May 15, 2019
BOARD OF COUNTY COMMISSIONERS
ORANGE COUNTY, FLORIDA

Y19-751-CH/Addendum #4

**CONNECTOR ROAD FROM HILTON DRIVEWAY TO APOPKA VINELAND ROAD
INTERSECTION IMPROVEMENTS**

Bid Opening Date: May 30, 2019

CROSS SECTIONS
 SHEET NO. 86

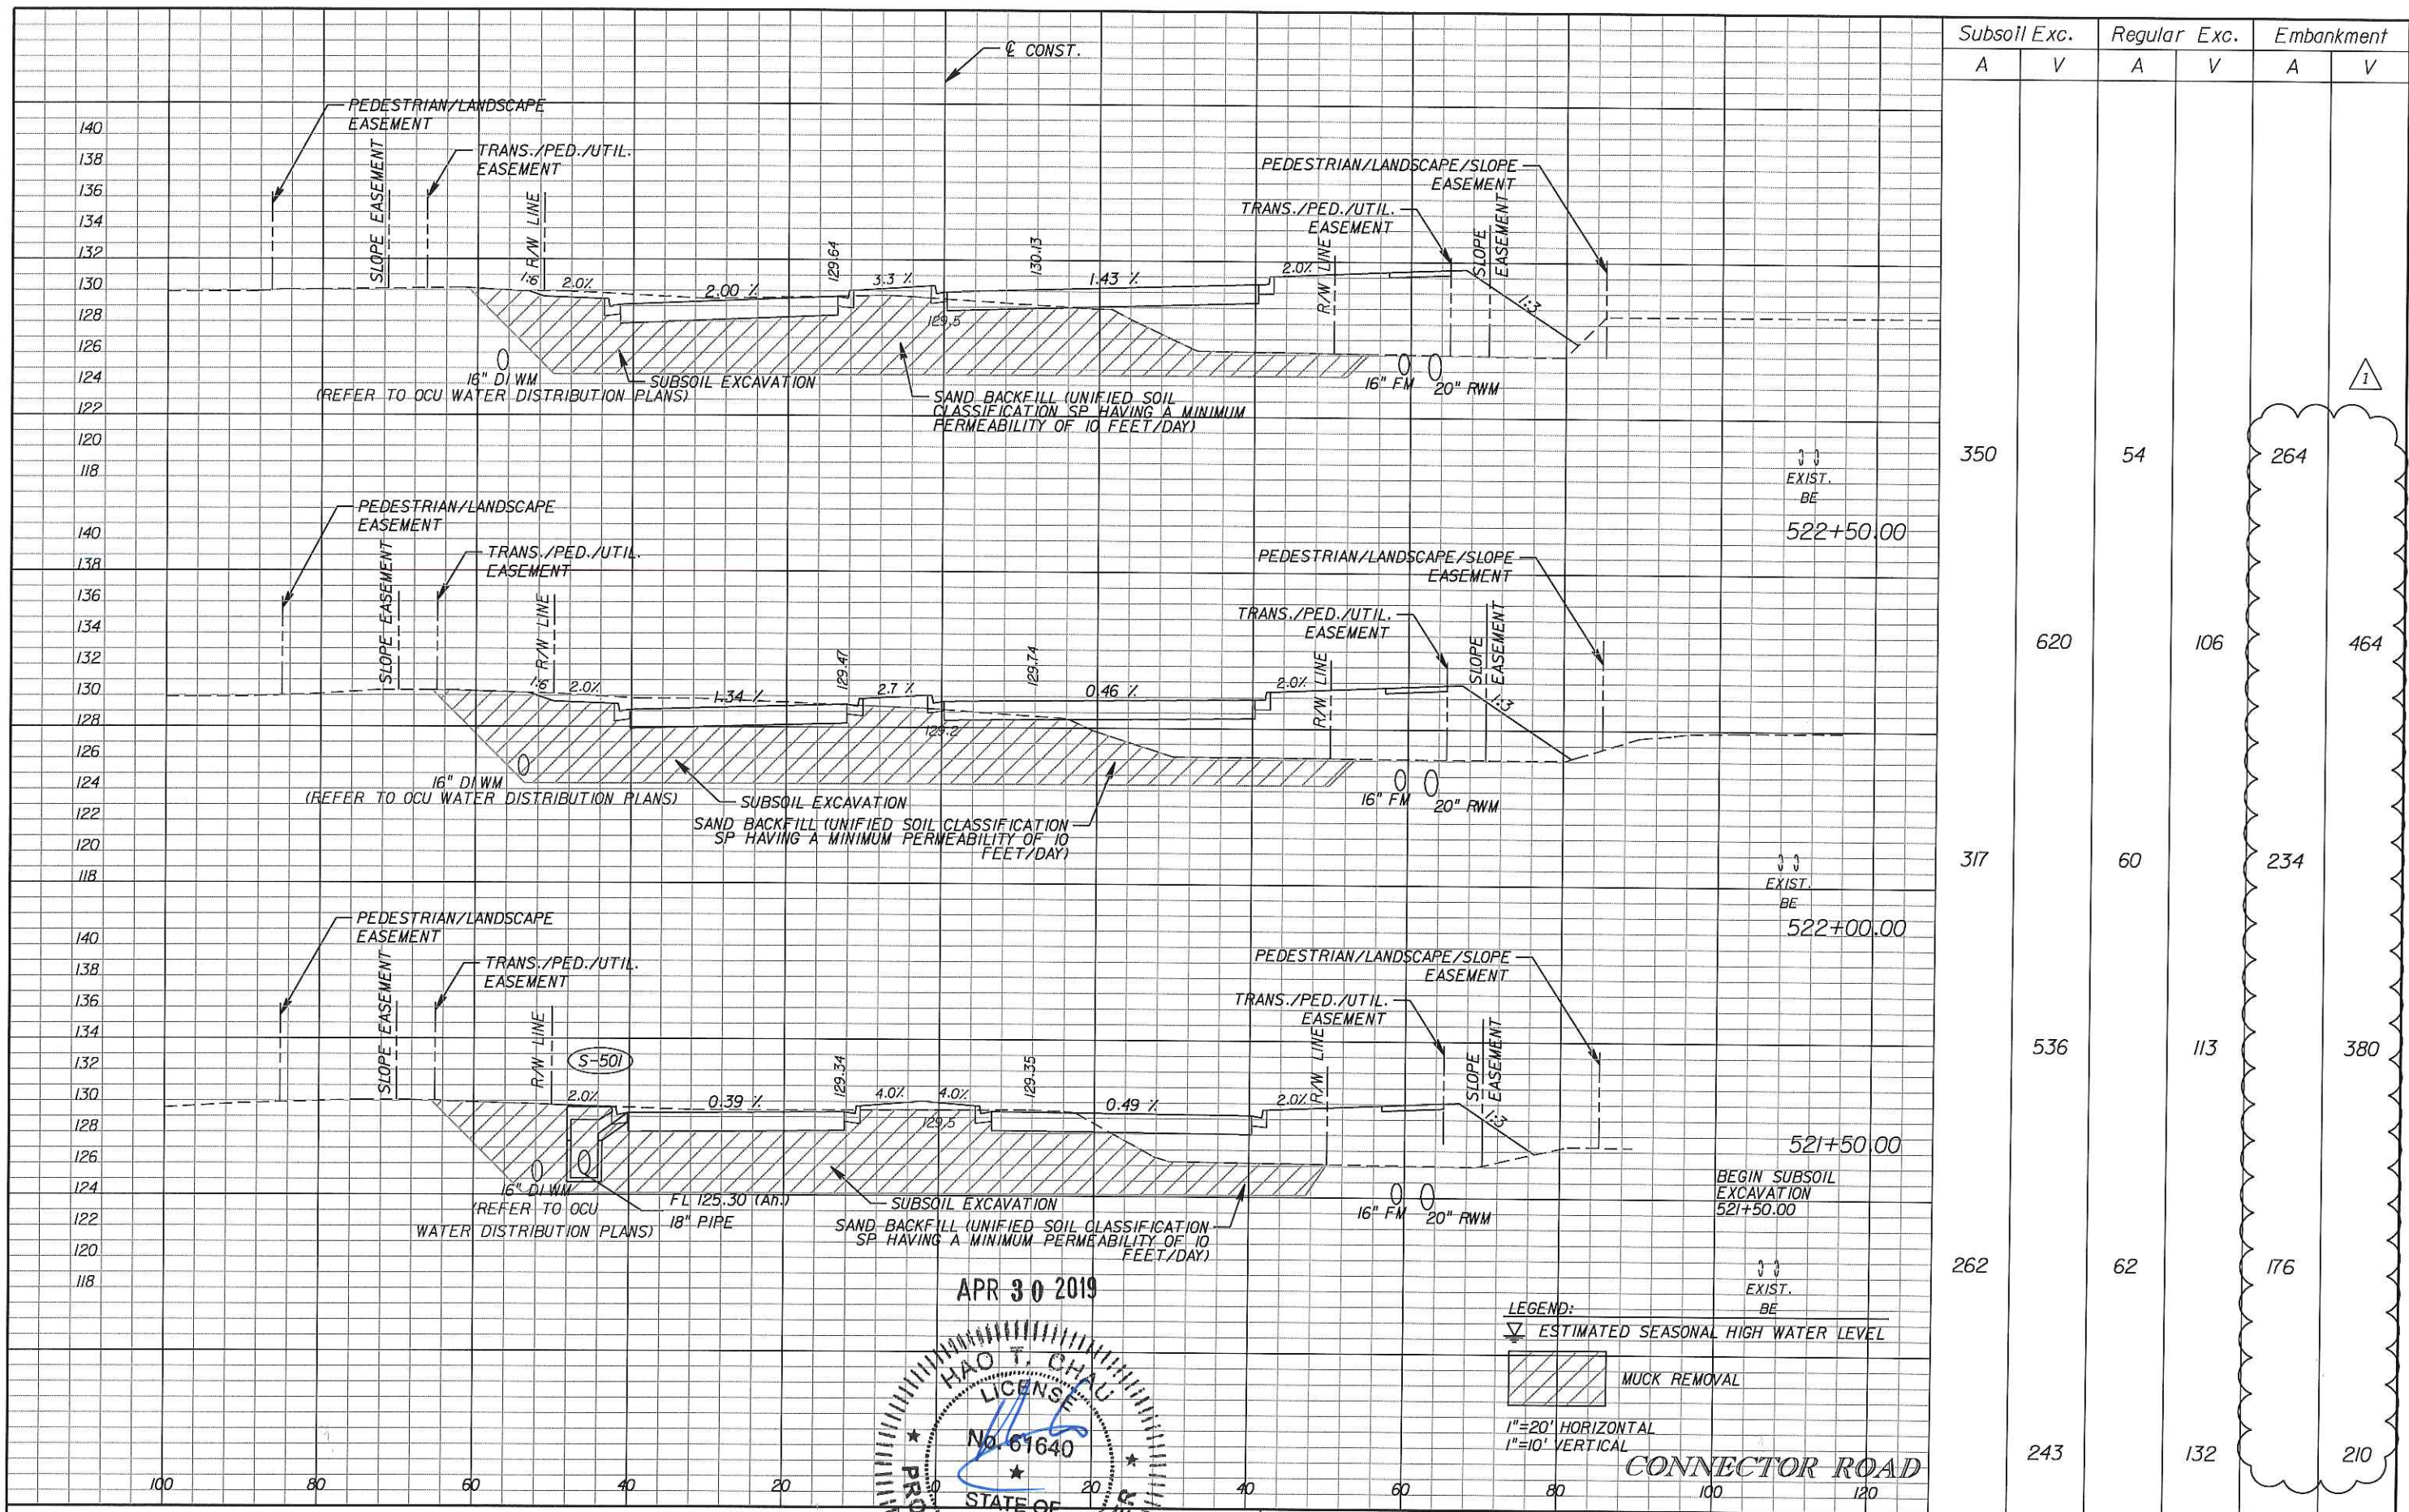
DATE	BY	DESCRIPTION	DATE	BY	DESCRIPTION
04/30/19	1	REVISED EMBANKMENT QUANTITIES & REMOVED SUBSOIL EXCAVATION AT STA. 521+00

SHEET NO.
87

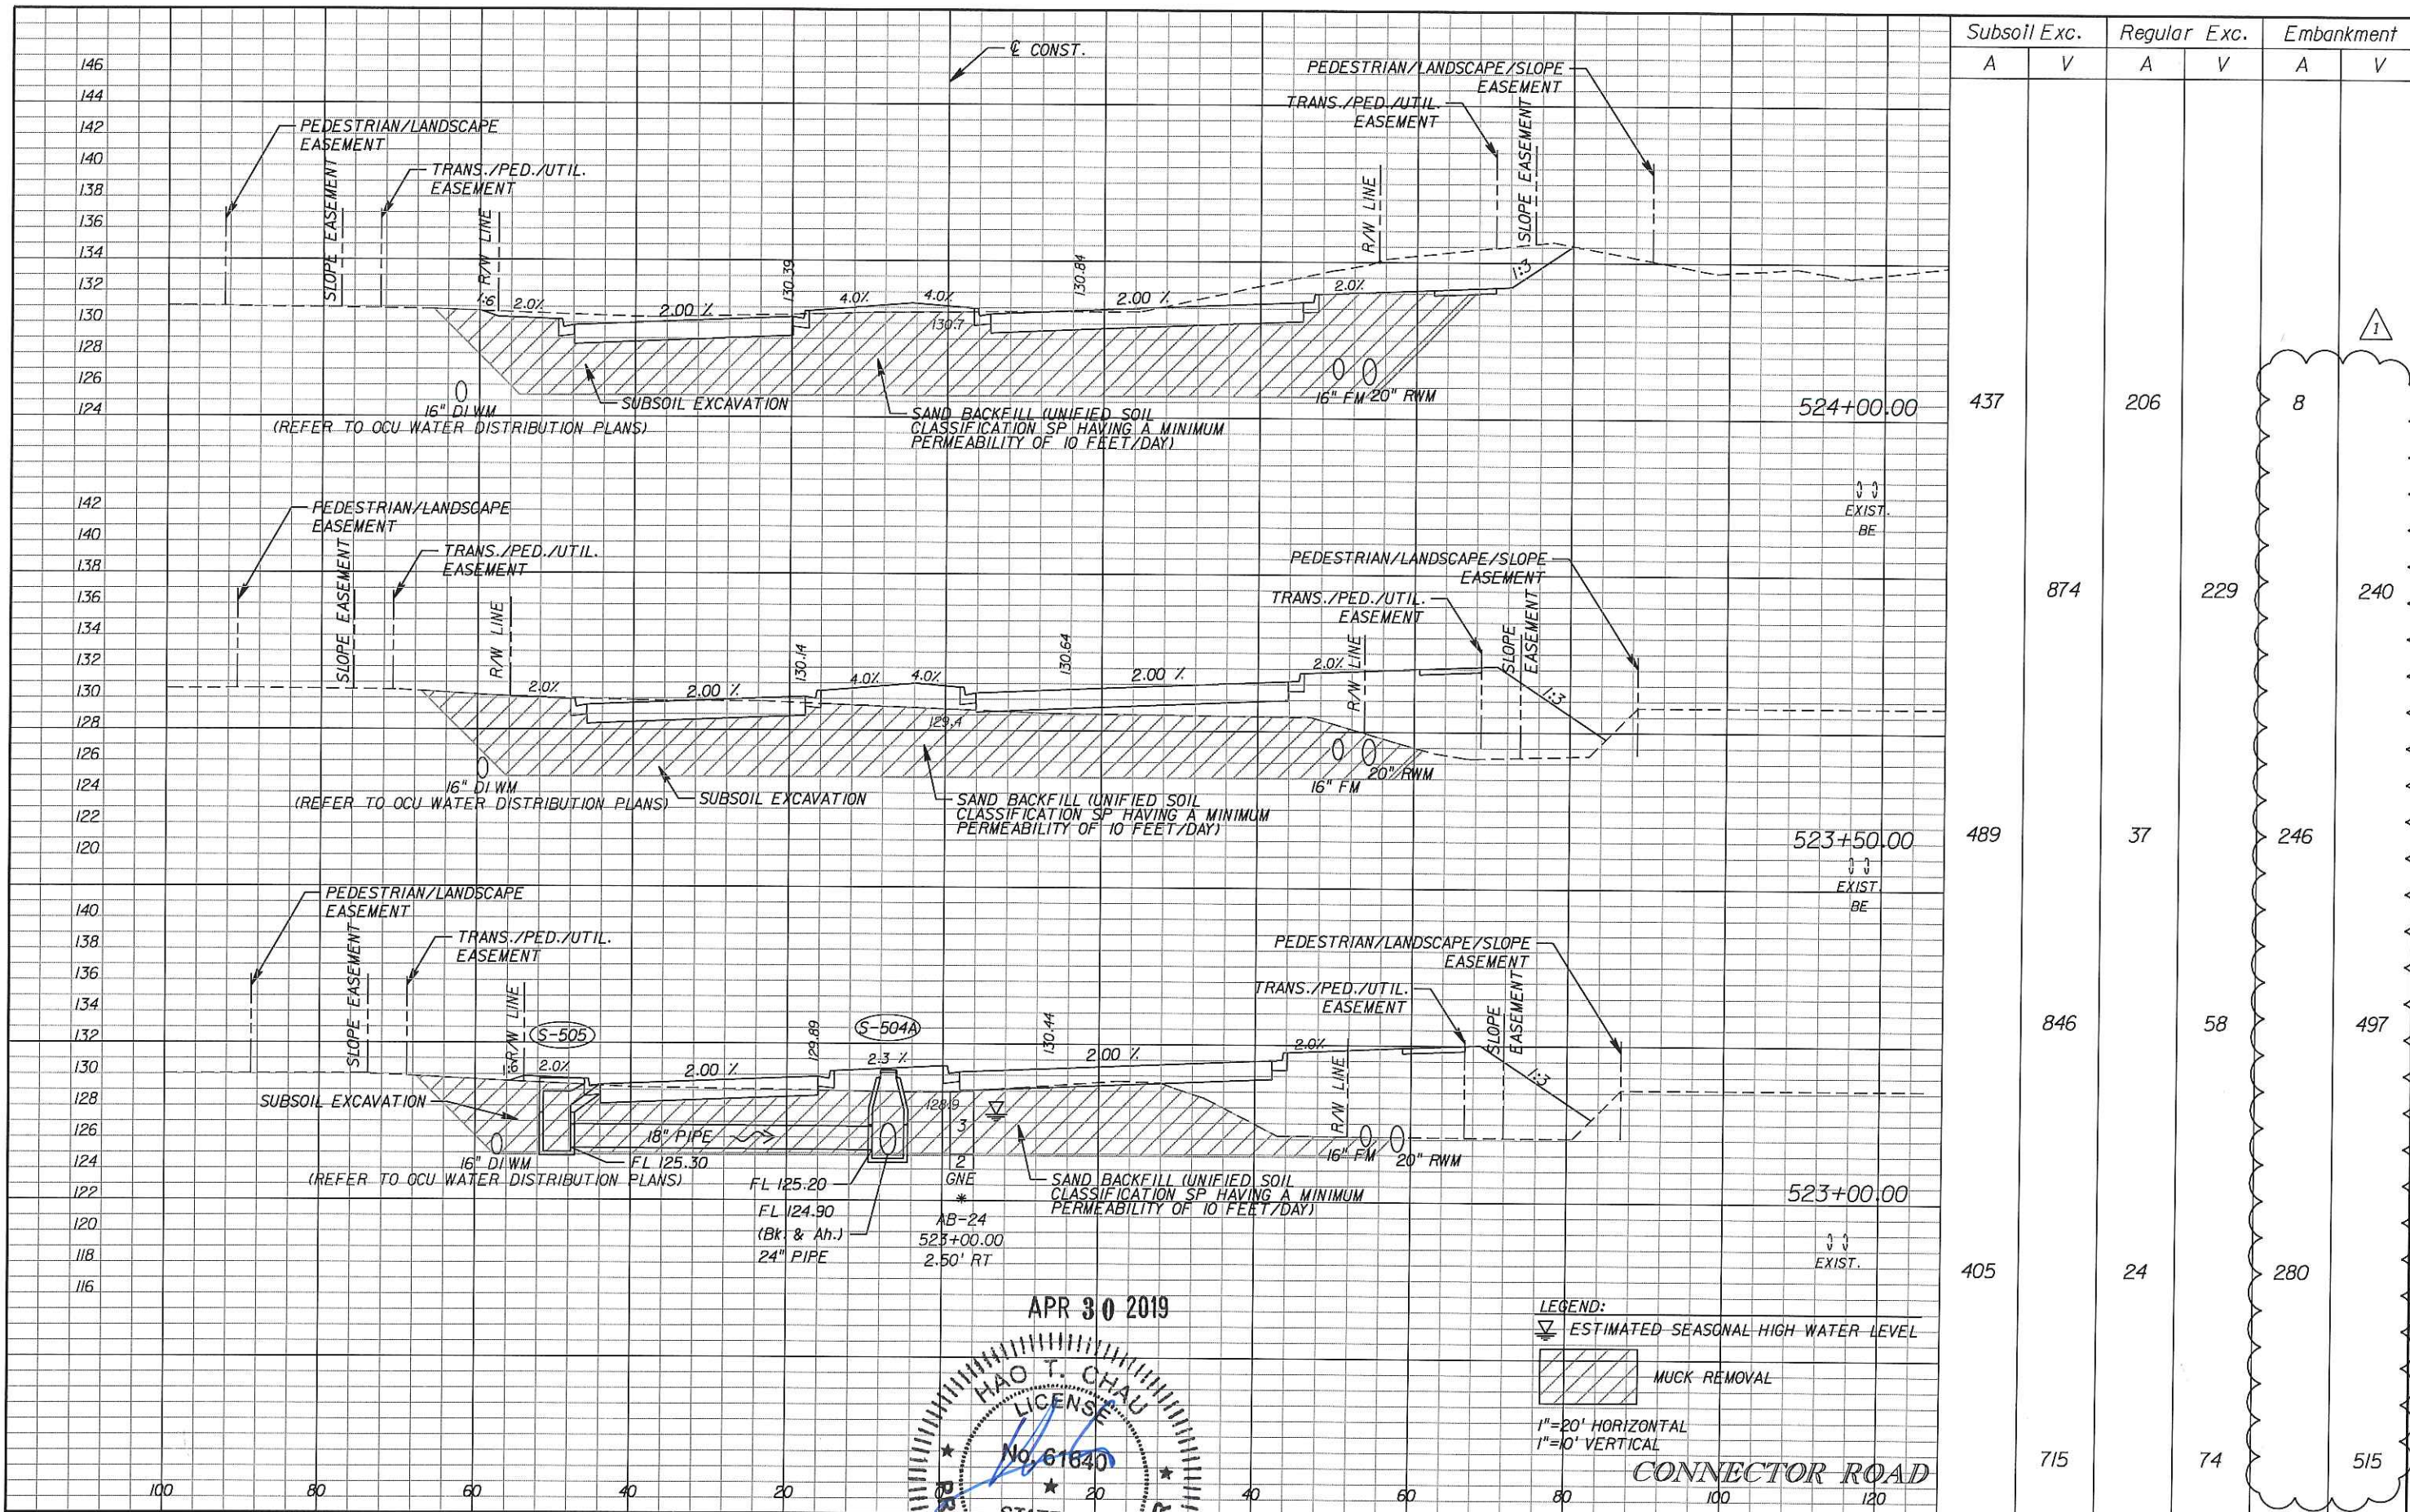
DATE	BY	DESCRIPTION	DATE	BY	DESCRIPTION
04/30/19		1 REVISED EMBANKMENT QUANTITIES

SHEET NO.
 88

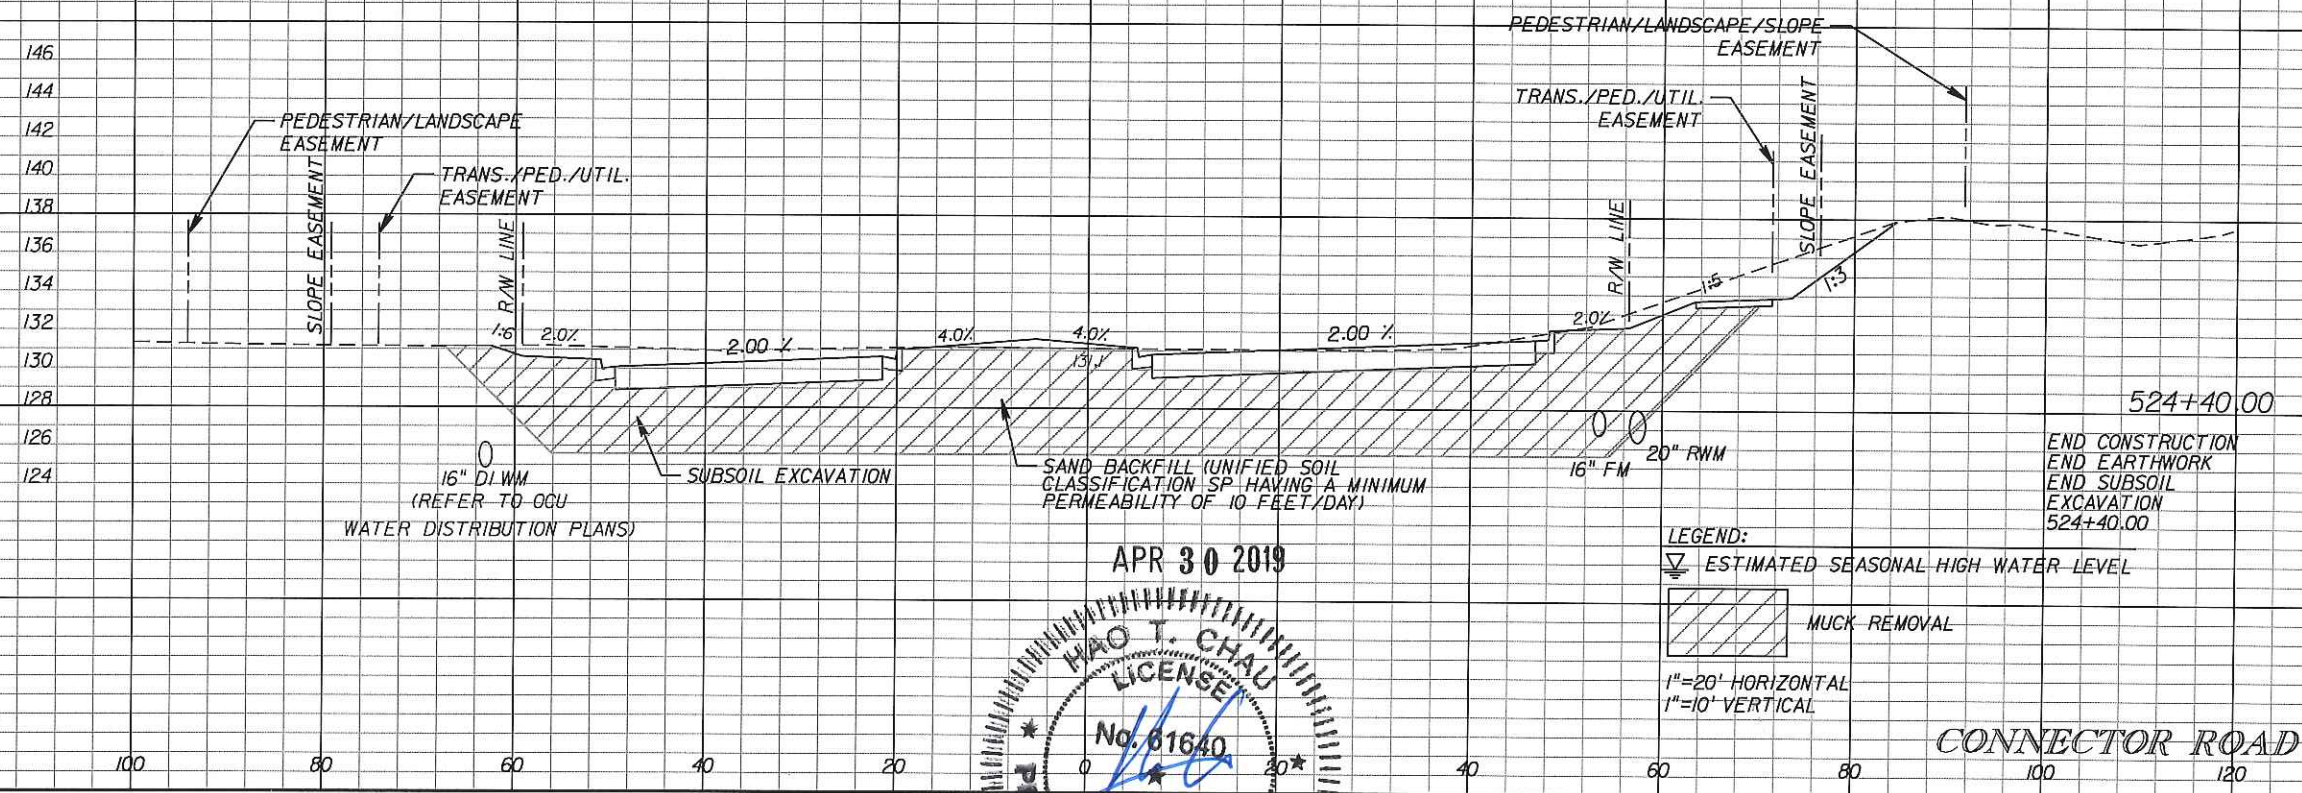
DATE	BY	DESCRIPTION	DATE	BY	DESCRIPTION
04/30/19	1	REVISED EMBANKMENT QUANTITIES
